No.	Description	Date
1	BUILDING COMMENTS	10/17/22

# Branch Facilities Office #18004 Puyallup, WA

BUILDING/PLUMBING/MECHANICAL PERMIT 2018 CODES

# H&R Block

## SITE PLAN

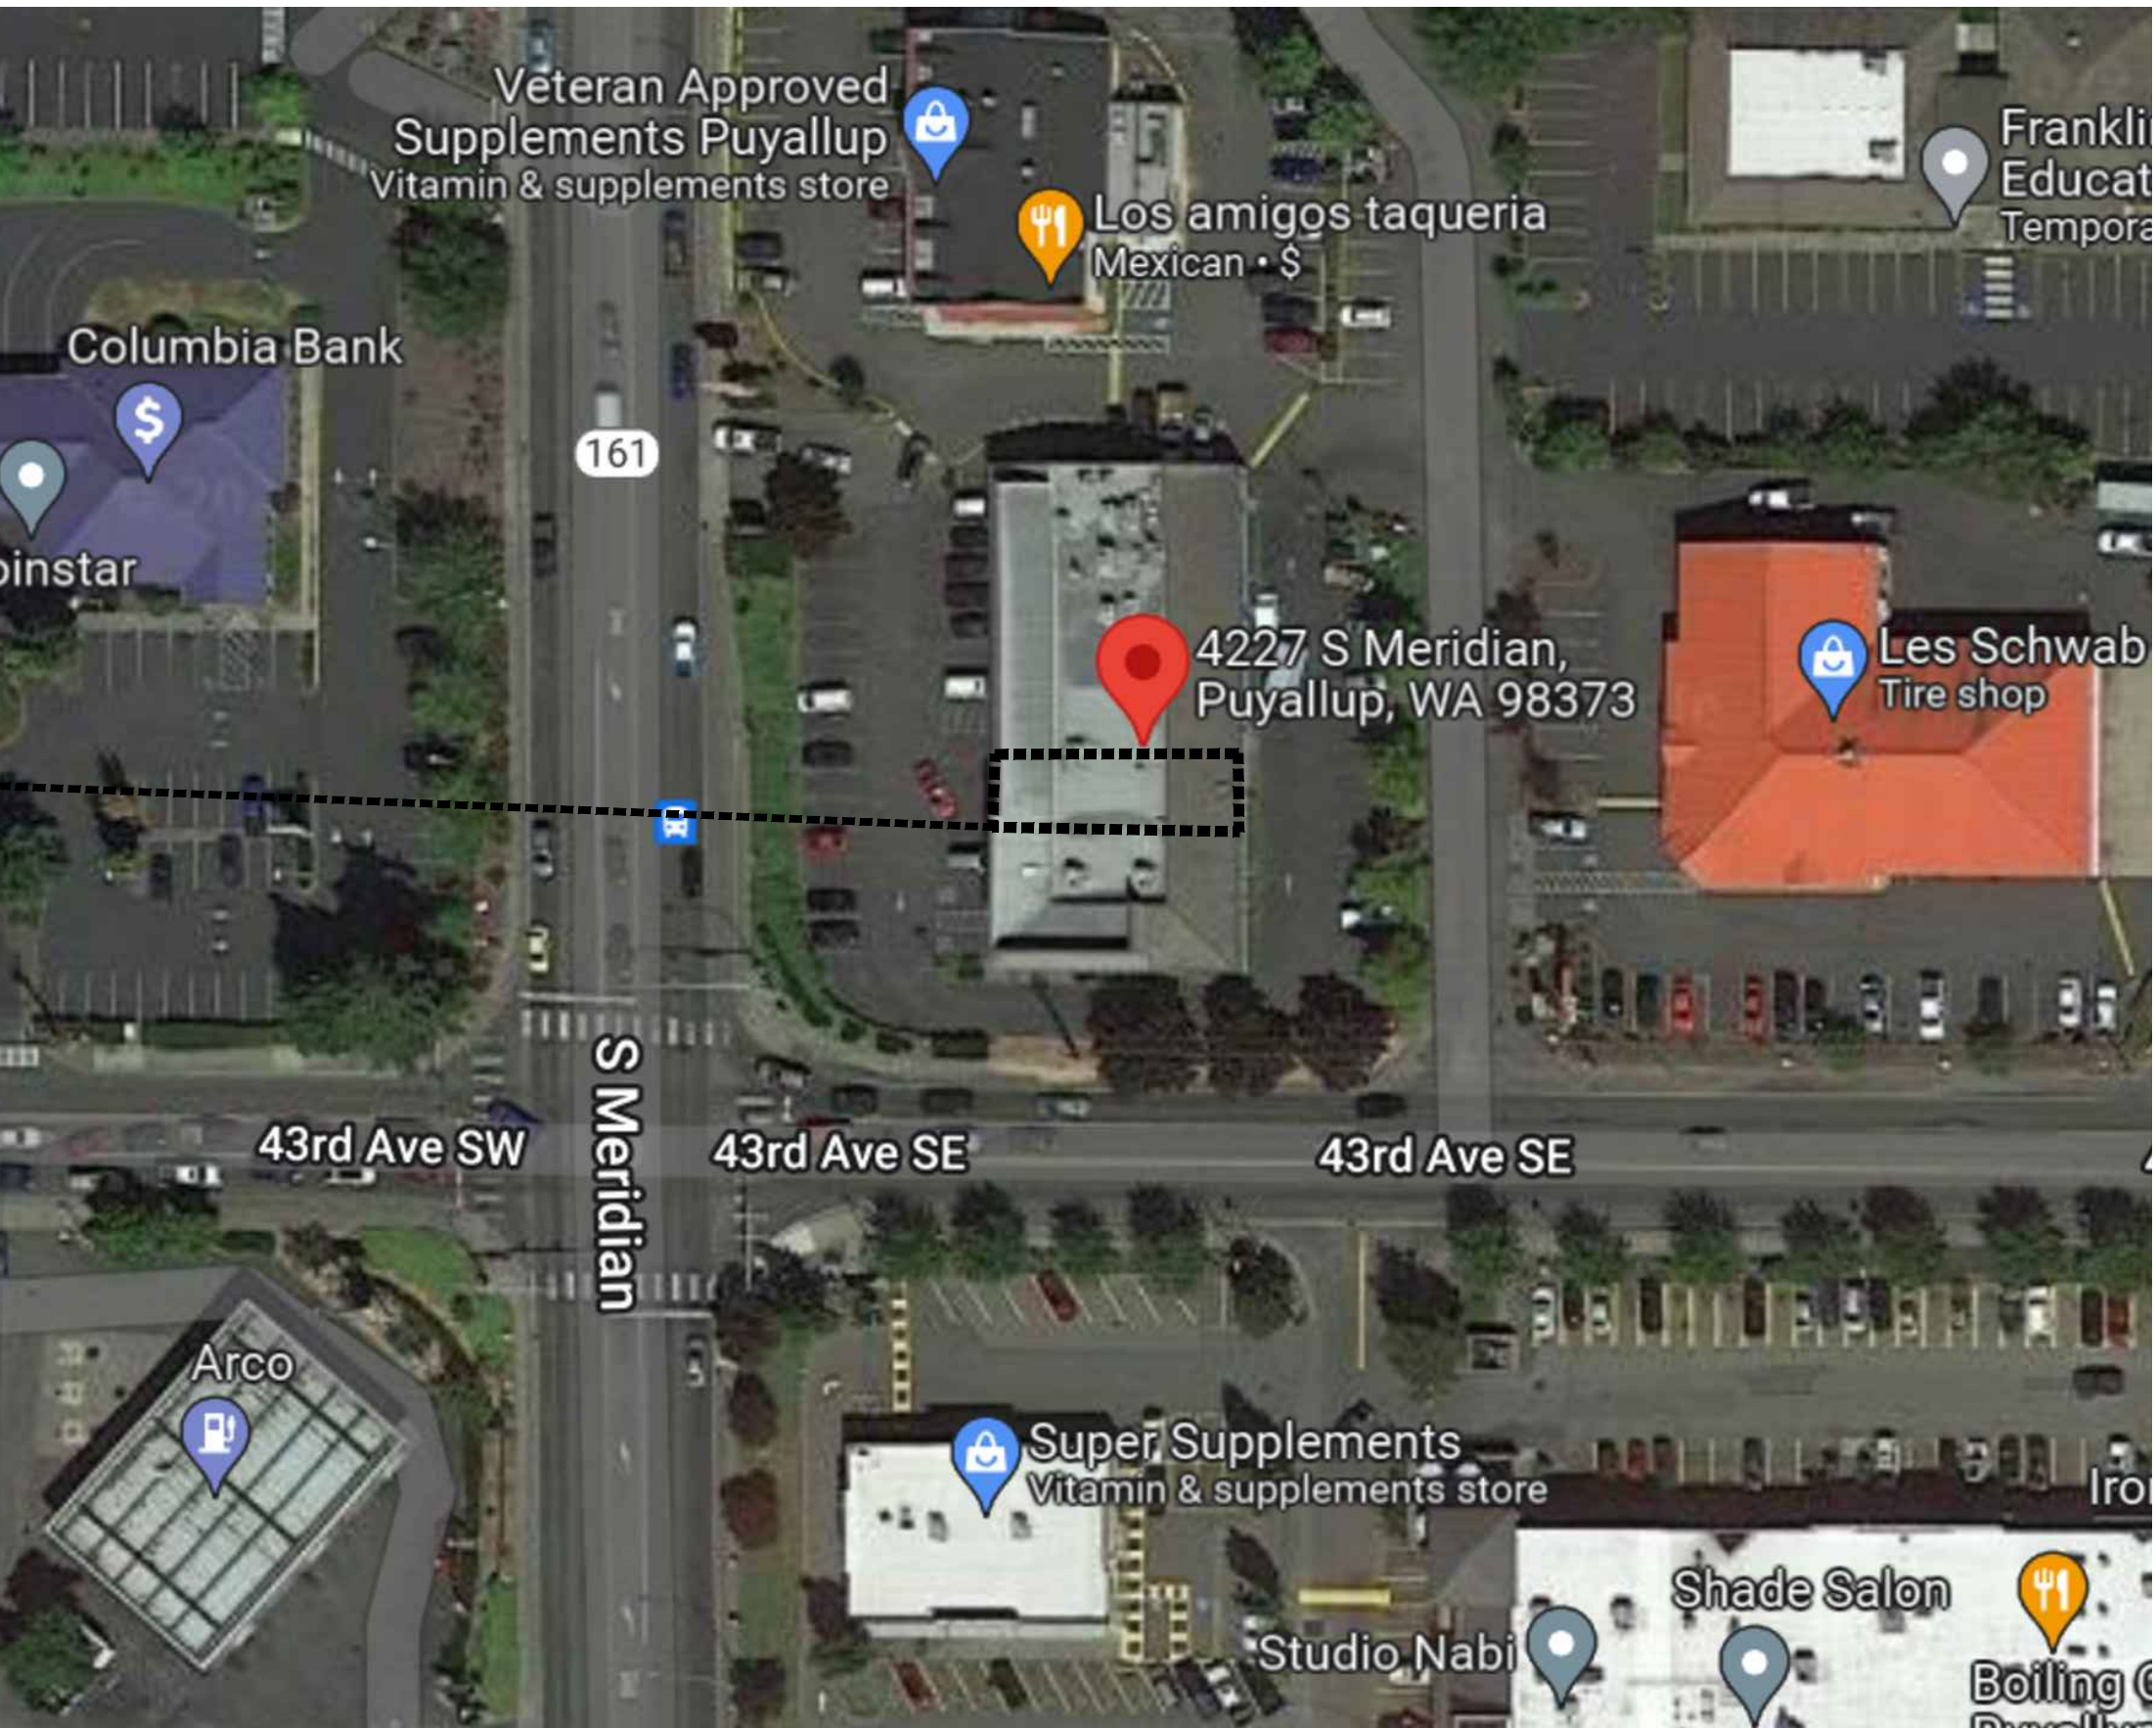
If a sewer sampling tee is not currently installed at this site the installation of one will be required prior to occupancy. A separate utility permit must be obtained prior to the installation of a sewer sampling tee

All commercial development must have a sampling tee installed on their sewer lateral. See Standard Detail 04.03.04

# 1 POWER AND SYSTEMS PLAN

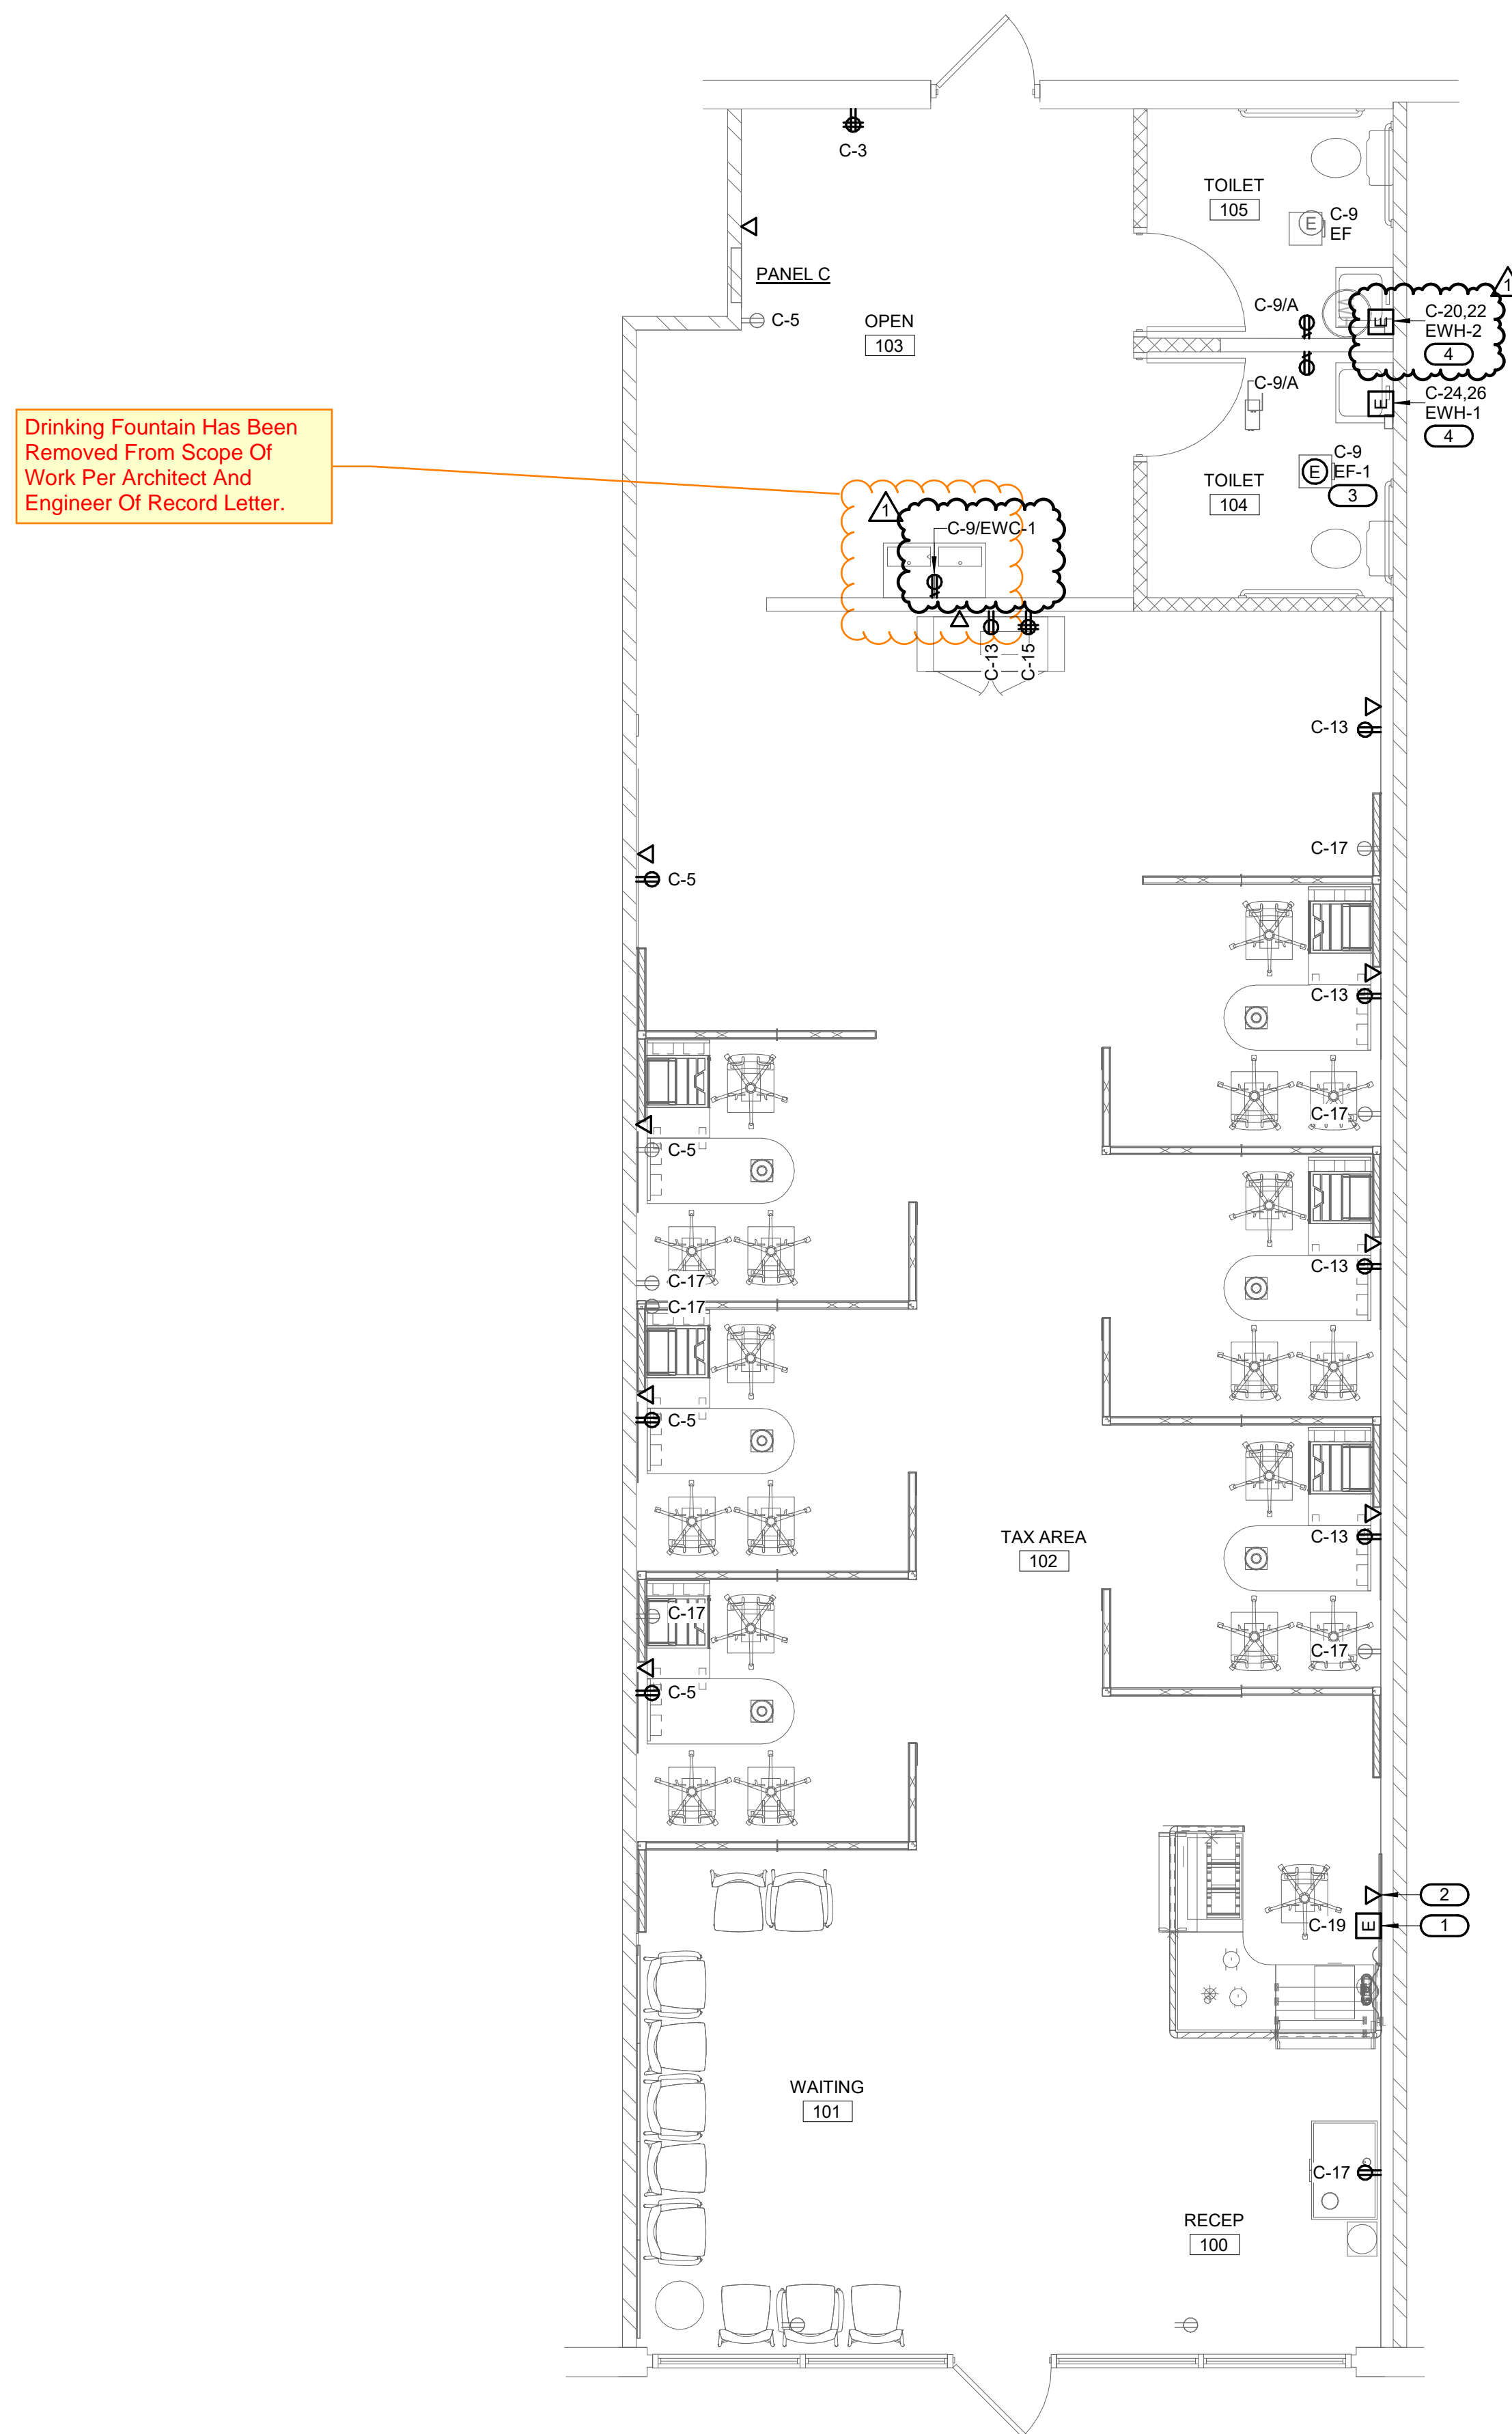
Drinking Fountain Has Been  
Removed From Scope Of  
Work Per Architect And  
Engineer Of Record Letter.

PLUMBING PLAN

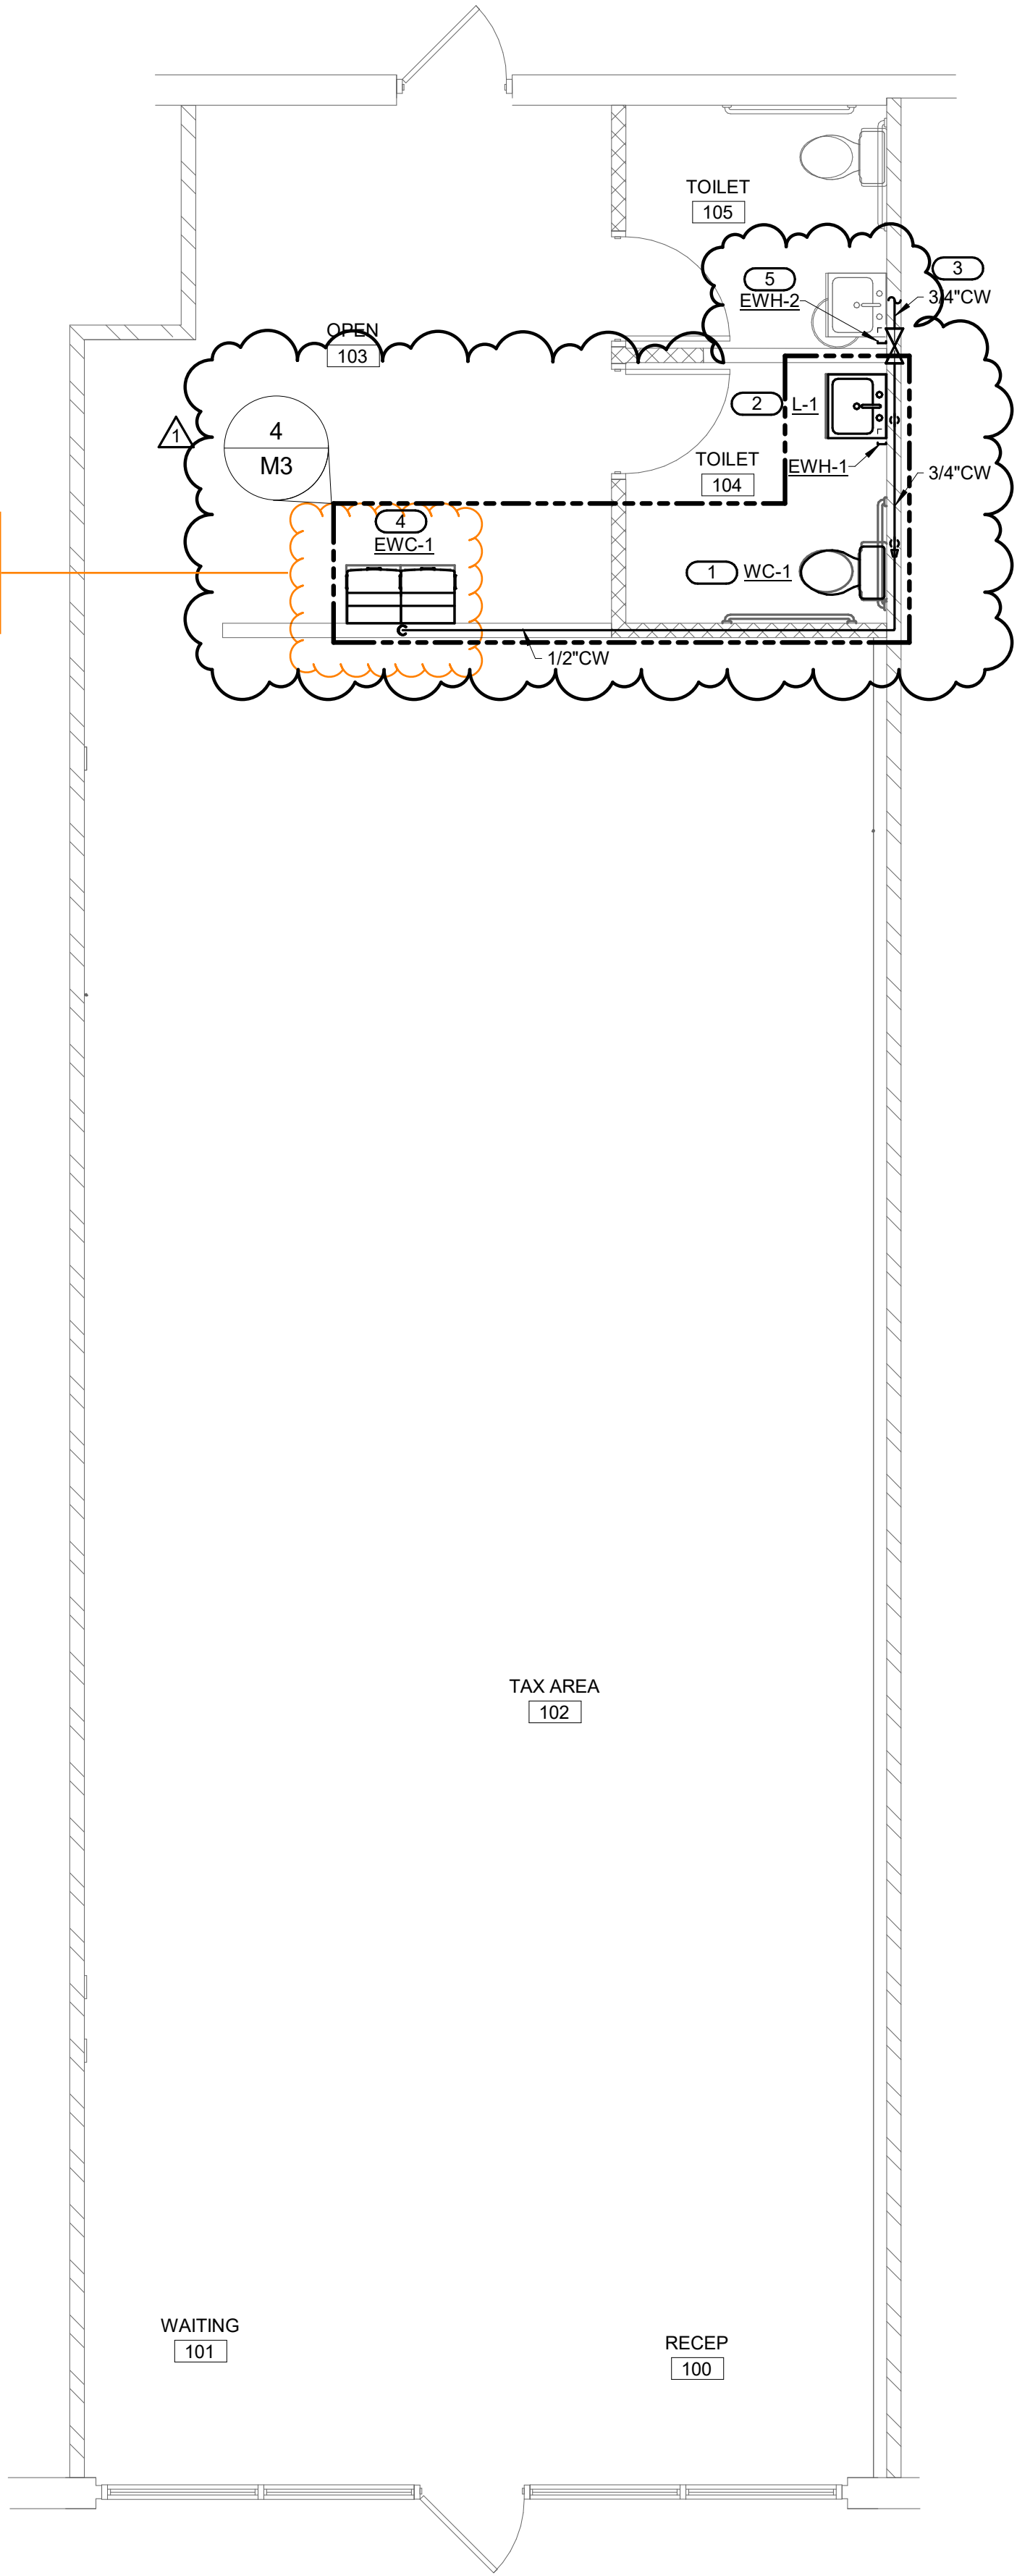
Drinking Fountain Has Been  
Removed From Scope Of  
Work Per Architect And  
Engineer Of Records Letter.
